TOWN OF PLAINFIELD PLAN COMMISSION REPORT

DATE: August 2, 2021

CASE NO.: [DP-21-074](#)

REQUESTED ACTIONS: Petition Seeking Architectural and Site Design Approval of a 715,307 square foot speculative distribution building on a 43.94 acre parcel zoned [I-2: Office/Warehouse Distribution](#) including [Development Incentives](#) for Depth of Yard.

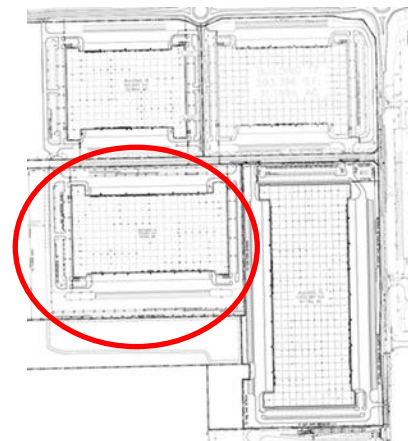
There are two additional buildings in the vicinity that are slated for the Commission’s agenda and the Commission recently approved Allpoints 17. The building that is the subject of this staff report is circled in red.
